Langfords Car Spares, Semley, Shaftesbury, SP7 9AQ

Planning App Ref: PL/2026/01038

Such Salinger Peters Ltd (SSP) are the Drainage Consultant working for the client on the above application. SSP have submitted a drainage strategy and flood risk assessment as part of these works. This letter is in response to the Wiltshire Council Drainage Team 'No Objection: Subject to Conditions' letter dated 2nd July 2026.

This letter report intends to set out the additional requested information in order to satisfy these conditions.

80757-12

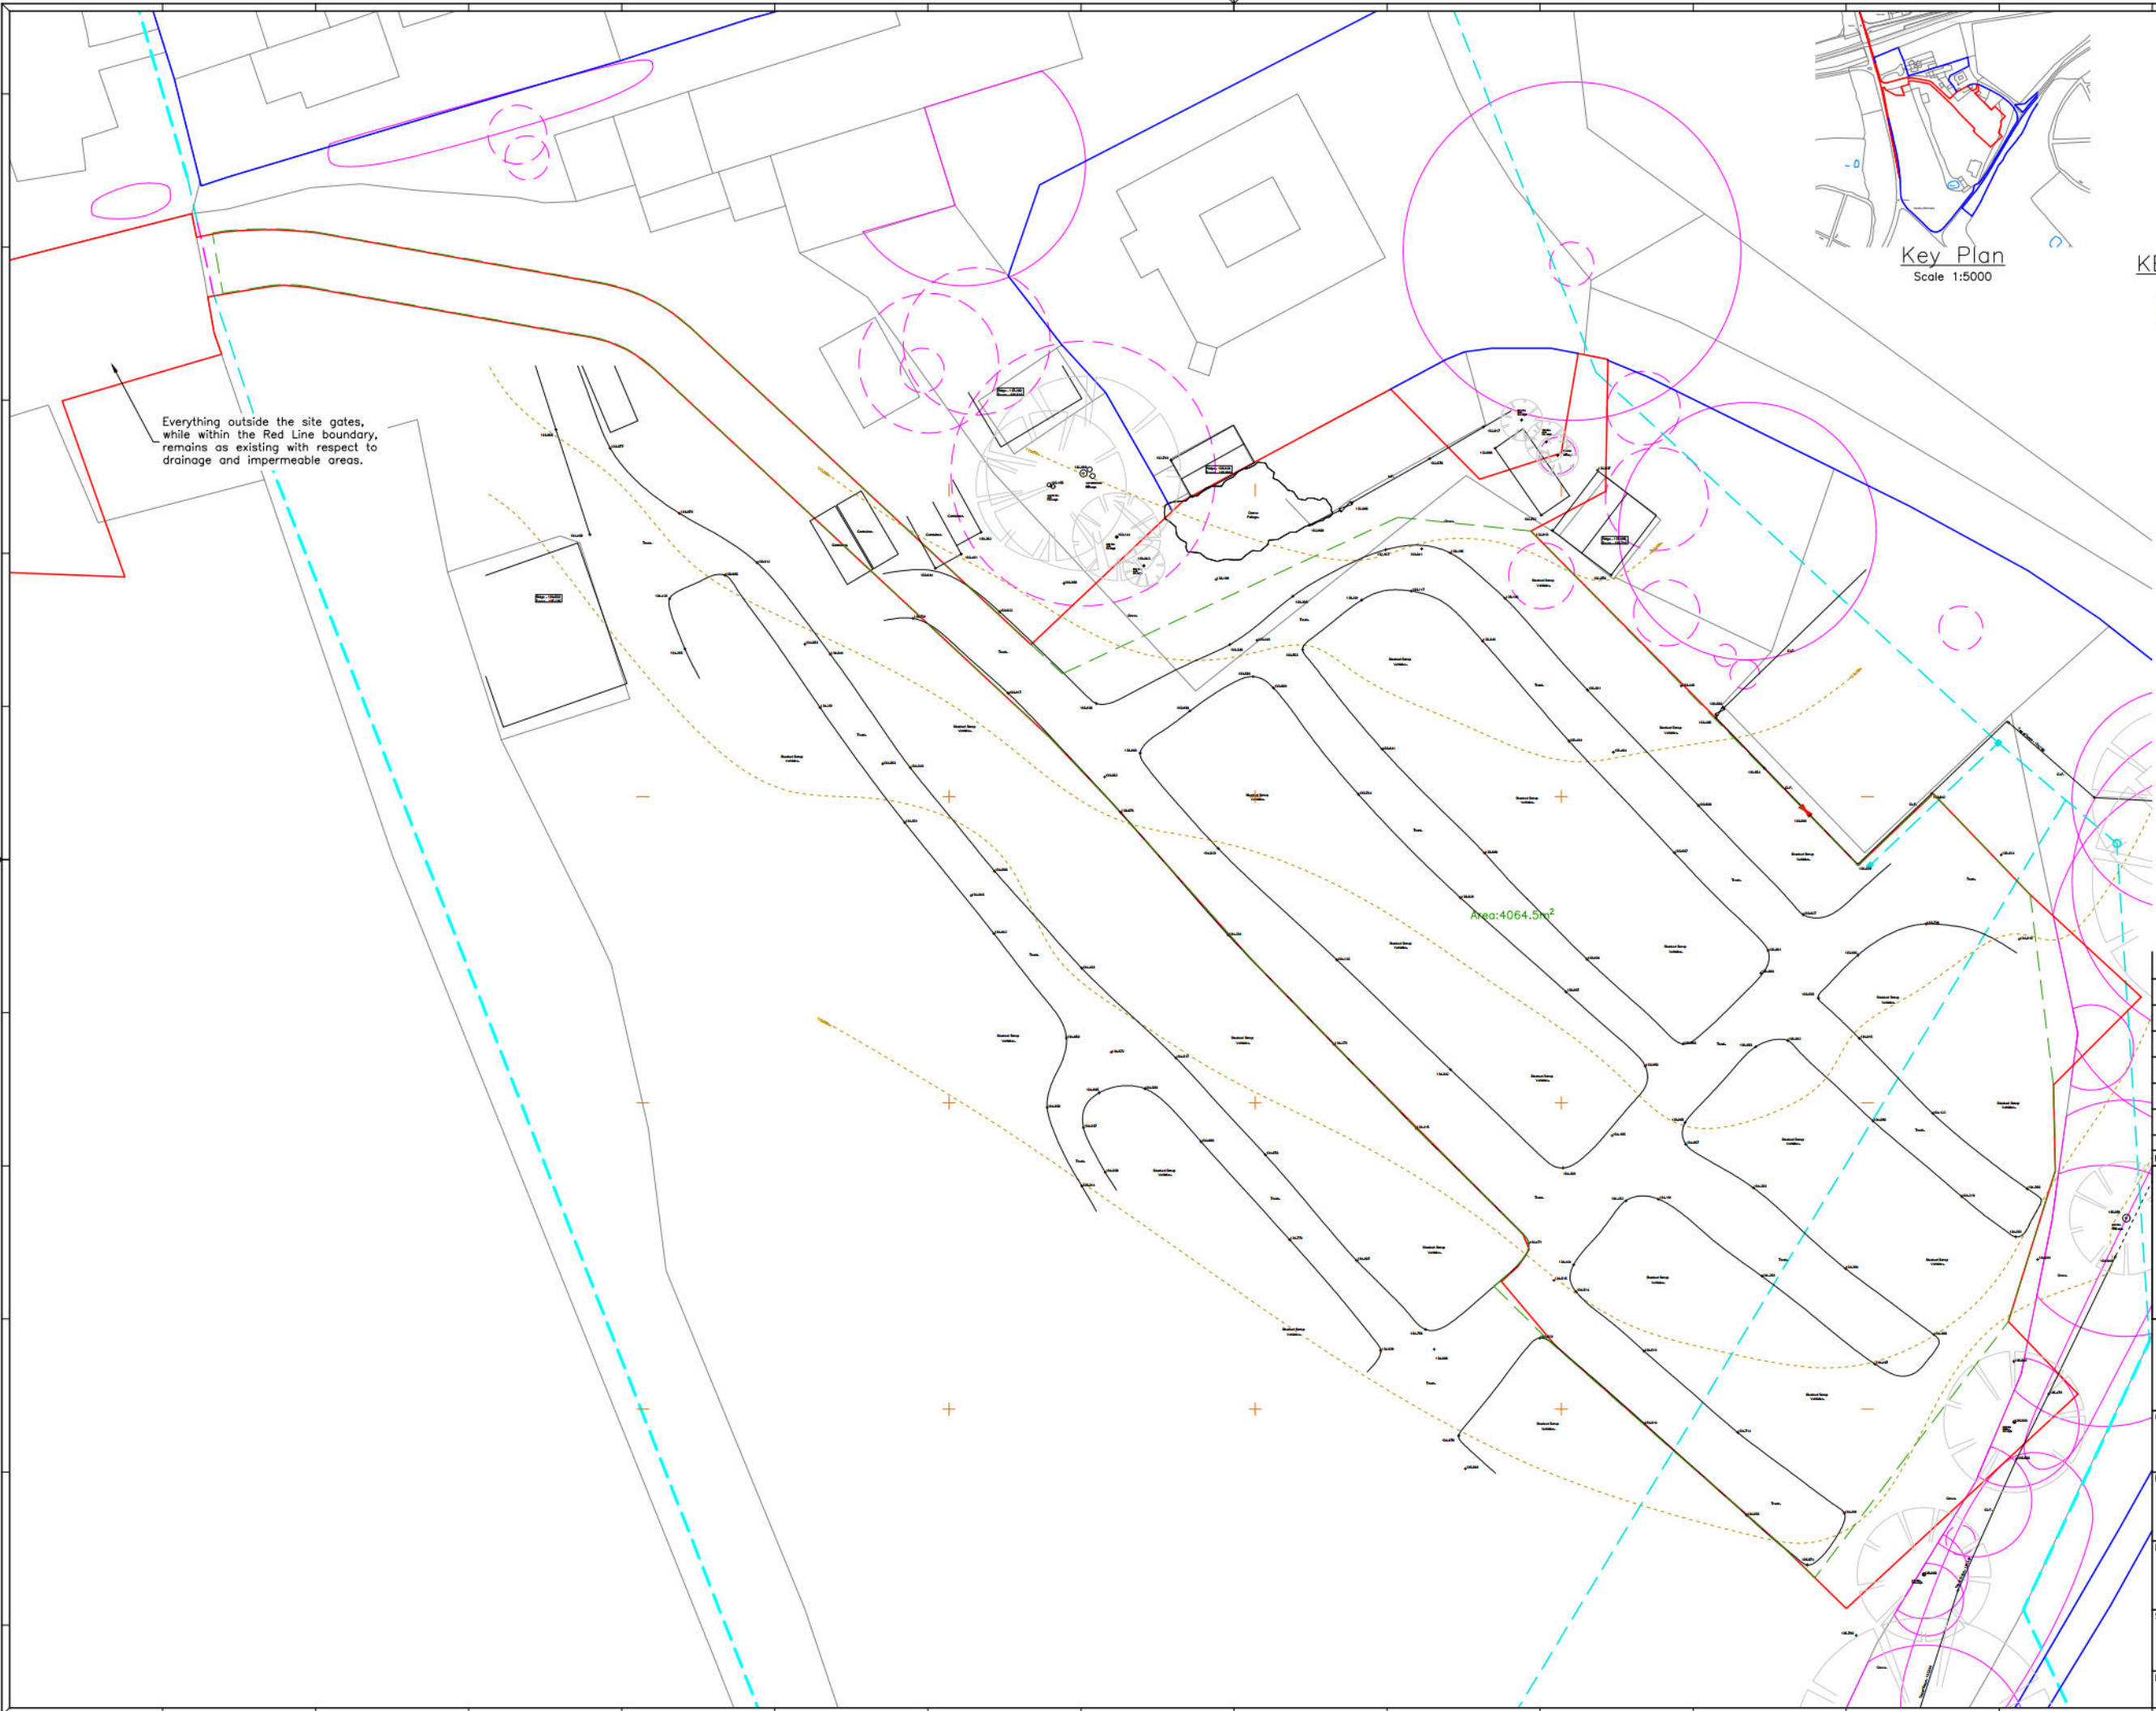
- *The applicant should provide a detailed drawing and sizing of the existing and proposed impermeable areas across the site and clarify how the introduction of an impermeable liner will alter the hydrological behaviour of the site and impact runoff generation.*

Drawing 80757-12 Existing Impermeable Area and Drawing 80757-04 Surface Water Drainage Strategy (including Proposed Impermeable Area) attached.

The existing site falls between the definitions of permeable and impermeable. The surfacing is compacted well graded aggregate (Type 1). However, there is a dense clay substrata at shallow depth that eliminates short term infiltration, meaning that for larger storms the entire area will behave as if it was impermeable. Furthermore, there is currently no attenuation or flow control on the existing surface water system.

The proposals to provide an impermeable barrier at the clay interface will be reproducing the existing drainage behaviour for larger storms. In addition, it allows the near-surface aggregate to act as storage despite the site topography, reducing the size of the tank and associated material import and export from site.

For both existing and proposed, the area outside the site gates has been ignored as it will remain unchanged. The proposed area is only that which is within the red line and will be impermeable (i.e. feed to the drainage system). This area has been used for the greenfield discharge rate to compare like with like. For the existing, the impermeable area includes all within the red line that is used for the current storage yard – this is

approximately 8% larger than the proposed impermeable area, but still 13% smaller than the red line (which due to the underlying clay will behave in a similar manner).
